**DOCKET ITEM #11****Rezoning #2014-0013, Development Special Use Permit  
#2014-0026, Encroachment #2014-0006****0 Prince Street, 200 & 204 Strand Street – Old Dominion  
Boat Club**

The applicant requests approval of a Rezoning/Map Amendment from W-1 to WPR, with proffer, an encroachment into the right-of-way, and Development Special Use Permit with modifications, to construct and operate a boat club building, and a Special Use Permit for a parking reduction.

**REZ #2014-0013, DSUP #2014-0026**  
**ENC #2014-006**  
**0 Prince Street, 200 & 204 Strand Street**

**Exhibit 2:** Tree well design for Strand Street shall include the following amendments:

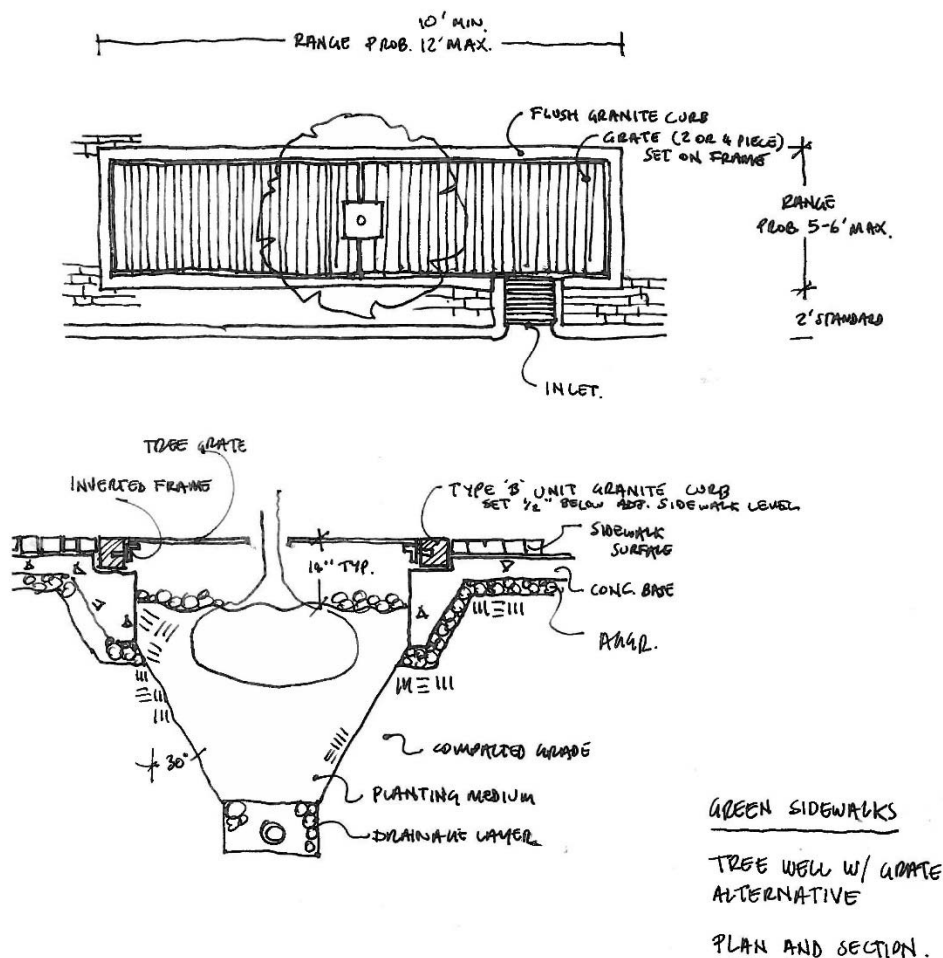
- 1) reduce the depressed soil level to that of a standard tree well with grate, and
- 2) remove the curbside inlet

**C1.0**

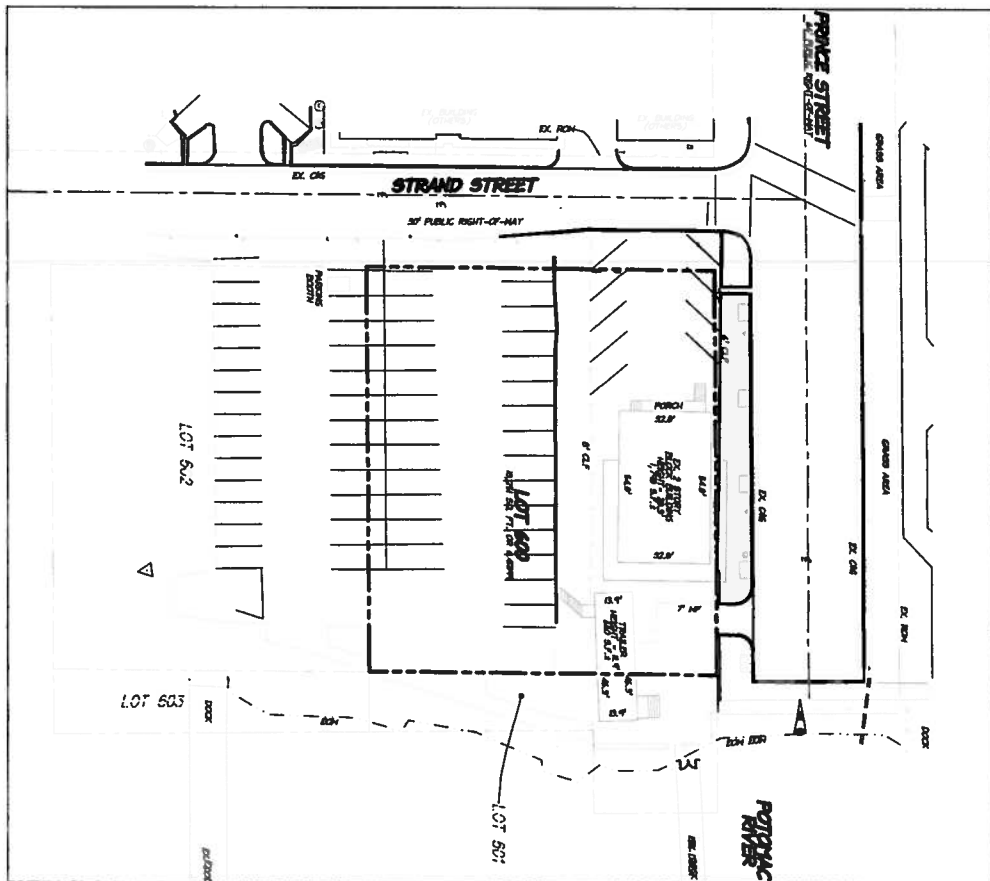
- F - 2. The narrative on Sheets C10.1 and C10.0 list the disturbed area as .64 acres, while the VRRM worksheets use .60 acres. Revise and make consistent. (T&ES- Storm)

- F - 3. The current plan shows the approximate scaled location of the RPA. The RPA shall be field-verified for subsequent submittals. The call-out references Note 10 incorrectly on C3.0, and the call-out needs to be consistent when used on other sheets. (T&ES- Storm)

- F - 6. The project lies within a possible methane-producing area associated with historic swamp areas. Revise the Environment Site Assessment on Sheet C2.0 to reflect this. (T&ES- Storm)
